Access Compliance Report Public Rights-of-Way (Pedestrian Signals)

Main Street: PERDIDO_ST Cross Street: BALL_RD Location: SW

ADA ID: SGRK210923173640 Signal Type: One Push Button-Non APS Overall Compliance: No Severity Scores: BTN 1: 35 BTN 2: N/A No BTN: N/A

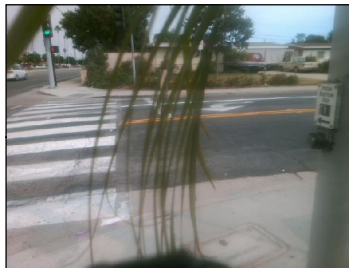
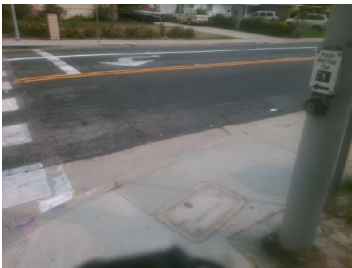
OC Std/PROW: R404.2, R404.3, MUTCD 4e.08

Possible Solutions: Replace Signal Push Button With APS Button. Remove and Replace Clear Space.
